**RESPONSE TO SUBMISSION (RTS)
Yennora Liquid Waste Treatment Plant
14-16 Kiora Crescent, Yennora (SSD 10407)**

Report No: 191251_RTS_Rev2
February 2021
(Released: 16 February 2021)

Figure 2-1: Driveway Works

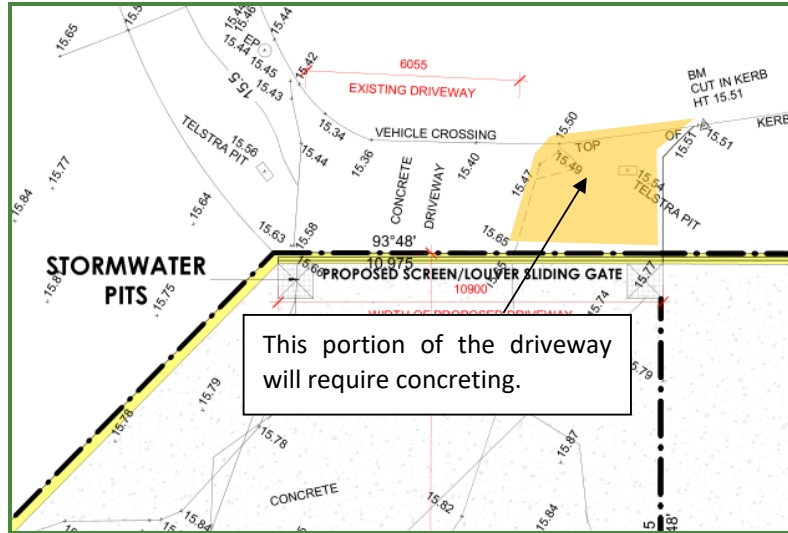
- The site plan provided in Appendix 1 indicates that works would be carried out to widen the site entrance at 16 Kiora Crescent. Please provide further description of these works. The width of the proposed driveway shown in the site plan extends over two existing stormwater pits. Please advise if these stormwater pits would be required to be relocated or managed to allow the widening of the site entrance. The proposed driveway widening works should also form part of the proposed development description and the be reflected in the QS report.*

- Update site plans to show the dimension of the site access upgrades proposed for the driveway entrance at 16 Kiara Crescent.

No changes to the stormwater pits will be required, they do not need to be relocated they can be driven over. Note: these stormwater pits are currently isolated and water is treated within the facility. The proposed driveway works are considered in the cost for external works within the QS report.

The site plans have been updated to show the dimensions of the site access upgrades proposed for the driveway entrance at 16 Kiara Crescent.

Figure 2-2: Proposed Truck Parking

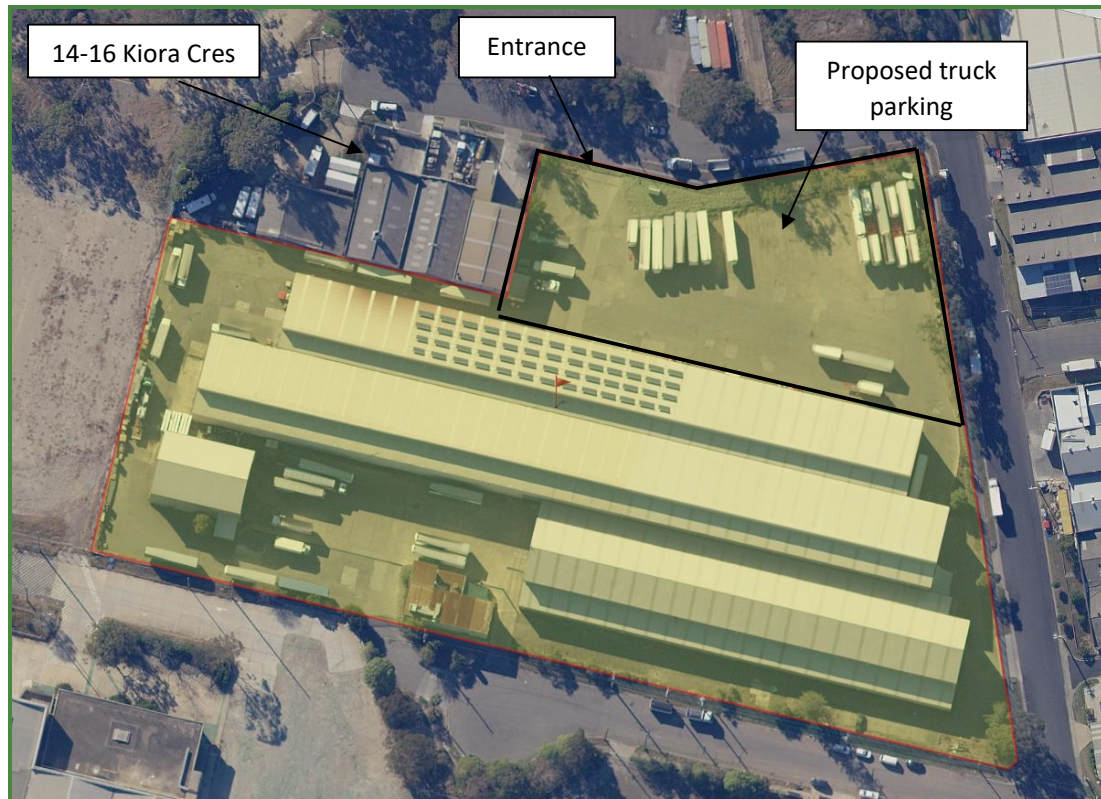
- *Provide a site plan for 49-53 Pine Road showing the site can suitably accommodate the Applicant's fleet.*

Response: This is no longer relevant. However, the following aerial photograph presents the truck parking area to be used at 27-49 Nelson Road, Yennora.
